Canon SERVICE MANUAL REPORT

Serial No. AC10-016

REGARDING CHANGED IN CHECKING METHODS FOR SHUTTER RELEASES OF CANON FX AND PELLIX

Pertaining to Light Leakage of Canon FX, FP

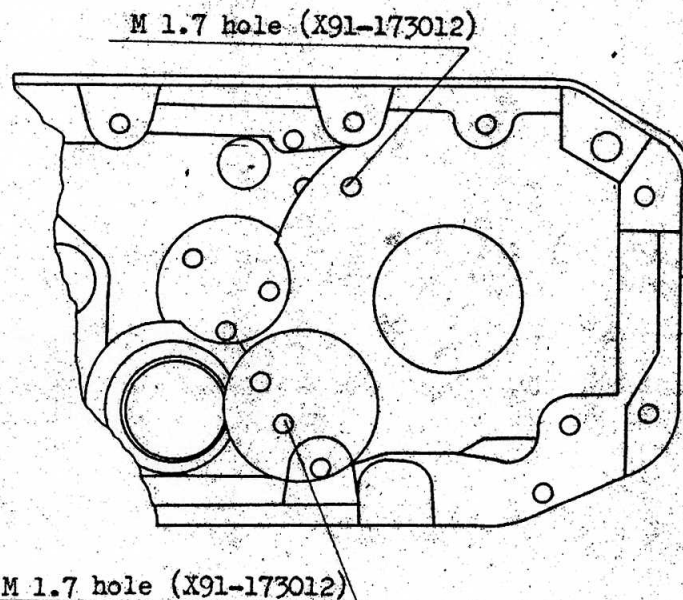
Body (19-9727) of Canon Pellix is diverted to body of Canon FX, FP at present time, however, as the body of Pellix has two more holes compared with the body of FX, FP, refer to the following diagram, if it is assembled without being covered a lid on the holes, there is a danger light might leak.

FX, FP of the body which has the screw holes without being covered a lid has only shipped approximately 150 - 200 pieces on 11th, 12th February, 1965 both FX, FP and the classification numbers are given as follows.

So if FX, FP which is assembled with this specific body returns to you for repair, no matter what light leaks or not, fill up screw X91-173012 to the holes mentioned above.

Altered Shutter Speed Dial 13-8155 of Canon FX, and FTQL

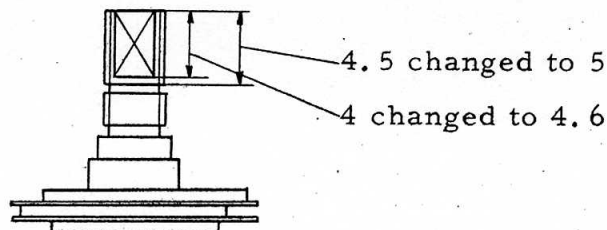
Oval hole position for Shutter Speed Dial 13-8155 of FX, FTQL is made altered to the same position Pellix as follows.

- 1 Shutter Speed Dial 13-8155

- 2 Shutter Speed Cam 19-9580

As for FX, if a new Shutter Speed Dial is fixed to the former Shutter Speed Cam, small end play may come out. In this case, cut down about 0.3mm at the bottom of Shutter Speed Dial, then fix it.

There is no question in FTQL, but as to FX, in case of fixing the former Shutter Speed Dial to a new Shutter Speed Cam, both Shutter Speed Dial and Shutter Speed Selector Base are not classified, therefore, take heed when the Shutter Speed Dial is replaced.

Top Cover

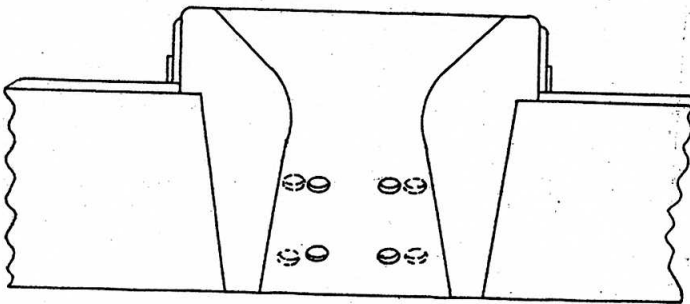
Position of screw hole has been changed.
Dotted line indicates old hole position.

19-9730-040 ———> 19-9730-05 (Pellix)
19-9517-11 ———> 19-9517-12 (FX)

Parts are not interchangeable.

Both the new and old parts are stored by the Service Department. Therefore, when requesting parts, be sure to indicate the parts number.

Body Case (B.P.)
19-9741

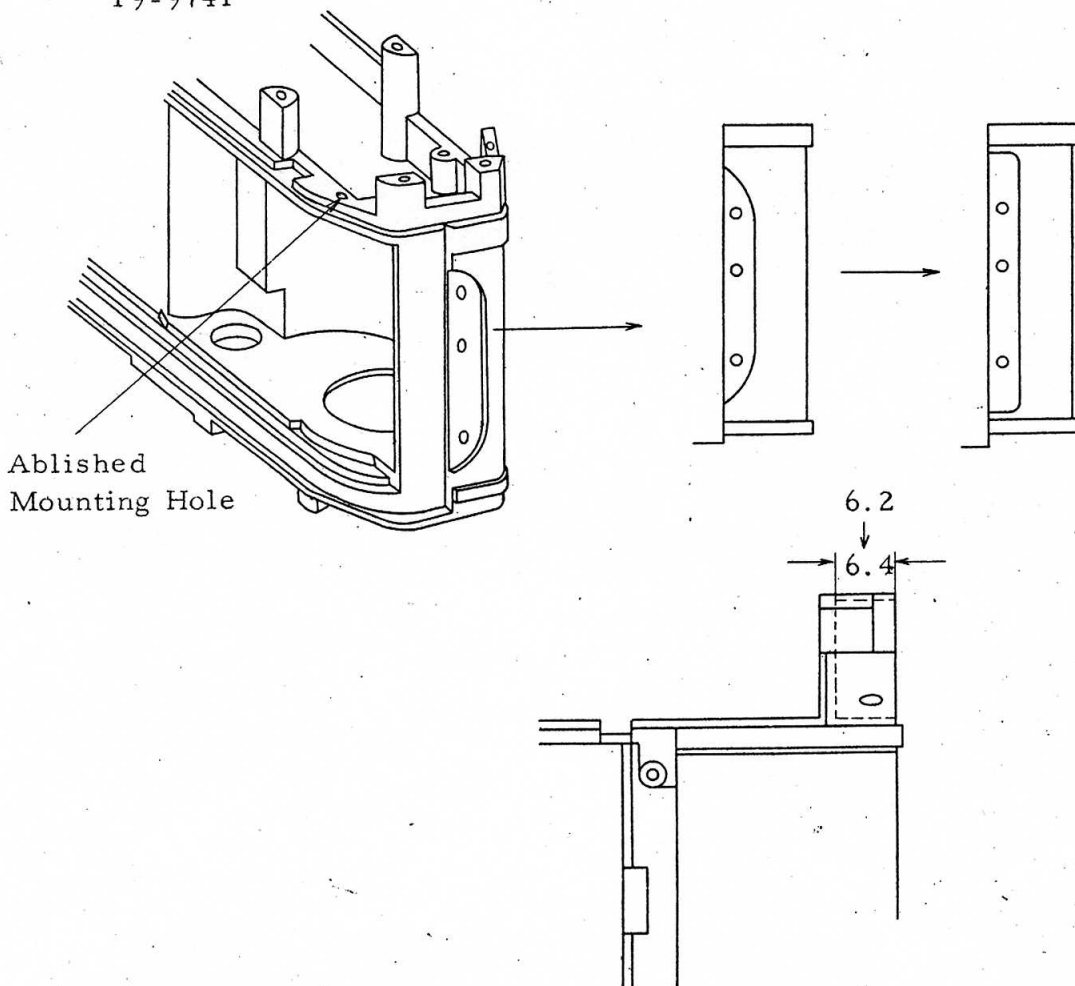
The part of Body Case (B.P.) 19-9741 where hinge is fixed, the part number has been previously altered from 19-9516, is made all common to FTQL and PXQL. The mounting hole of Screw X91-142379 for Reset Lever is abolished. The depth 6.2mm of the Mercury Battery Box is also altered to 6.4mm as well as FTQL and PXQL.

The number 13-8372 Battery Cover is altered to 13-8372-05.
The material vinyl chloride is altered to polypropylene and the
thick 0.2mm is altered to 0.4mm. The number 13-8368
Insulator is altered to 13-8368-03.

The number 13-8326 Hinge is altered to 13-8948.

13-8326 is stopped, then 13-8948 which is common to FTQL and
PXQL is applied instead. Collar 13-8521 and Screw X91-142379
are stopped.

Old Hinge 13-8326 can't be used to the new Body Case.
Old Mercury Cover 13-8372 can't be used to the new Body Case.
Old Insulator 13-8368 can't be used to the new Body Case
19-9741-12, but the new Insulator 13-8368-03 can be used to the
old Body Case 19-9741.

Modified Top Cover and Base Plate, Canon FX

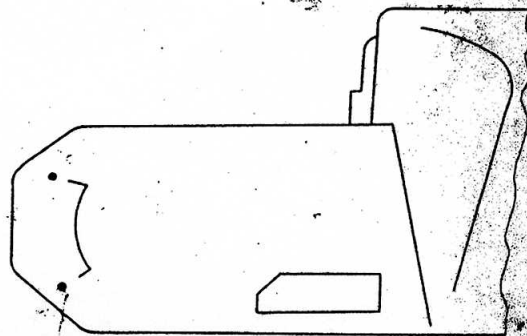
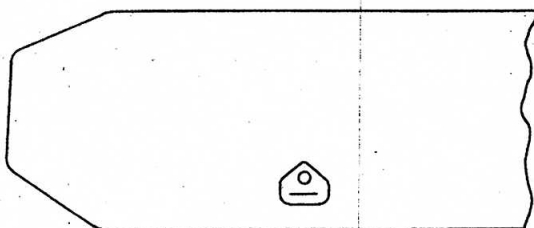
With the alteration of the name, ~~the top cover and the base plate~~ are modified. The carving **CANON CAMERA COMPANY, INC. NO. 100001 MADE IN JAPAN** on the backside at right hand side of the cover is abolished, but 100001 is put on the surface at left hand side instead and **CANON JAPAN** is also put on the surface of the base plate.

CANON CAMERA COMPANY, INC.
NO. 100001 MADE IN JAPAN
19-9517

19-9517-14

19-9521-05
